Access Compliance Report

Public Rights-of-Way

Intersection ID: N/A	Main Street: MINTVALE_DR	Cross Street: PALUSTRIS_CT	Location: S
ADA ID: B8C0B6E4F03F	Ramp Type: Perp	Initial Pass/Fail: Fail	Overall Compliance: No
Severity Score: 13.75			
Codes/Mitigation Info/Possible Solution		Field Measurements/Component Compliance

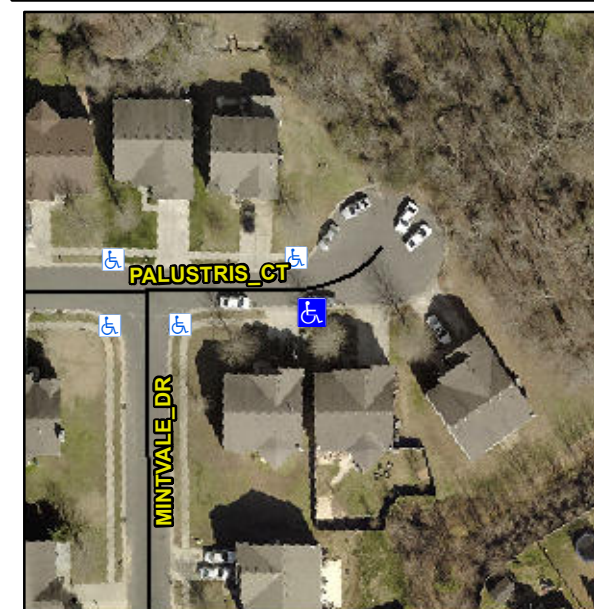
Not Found, R304.2.2, R304.5.3

Compliance	Description	Data	Compliance	Description	Data
N/A	Ramp Length (in)	46.5	No	Ramp Slope (%)	8.8
Yes	Ramp Width (in)	81.0	No	Ramp XSlope (%)	2.1
N/A	Flare Type LT	N/A	N/A	Flare Type RT	N/A
N/A	Flare Slope LT (%)	N/A	N/A	Flare Slope RT (%)	N/A
N/A	Flare Traversable LT?	N/A	N/A	Flare Traversable RT?	N/A
N/A	Landing Length (in)	N/A	N/A	DWS Provided?	N/A
N/A	Landing Width (in)	N/A	N/A	DWS Contrast?	N/A
N/A	Landing Slope (%)	N/A	N/A	DWS Length (in)	N/A
N/A	Landing X Slope (%)	N/A	N/A	DWS Full Width?	N/A
N/A	Landing Curb? (Y/N)	N/A	N/A	DWS Offset (in)	N/A
N/A	Shared Landing?	N/A			
N/A	Gutter Ponding?	N/A	N/A	Gutter Slope (%)	N/A
N/A	Gutter Lip Ht (in)	N/A	N/A	Gutter X Slope (%)	N/A
N/A	Painted X Walk1?	No	N/A	Painted X Walk2?	N/A
	X Walk 1 Direction	To N		X Walk 2 Direction	N/A
N/A	X Walk 1 Width (in)	N/A	N/A	X Walk 2 Width (in)	N/A
	X Walk 1 Slope (%)	3.9		X Walk 2 Slope (%)	N/A
	X Walk 1 X Slope (%)	0.1		X Walk 2 X Slope (%)	N/A

Remove & Replace Entire Ramp.
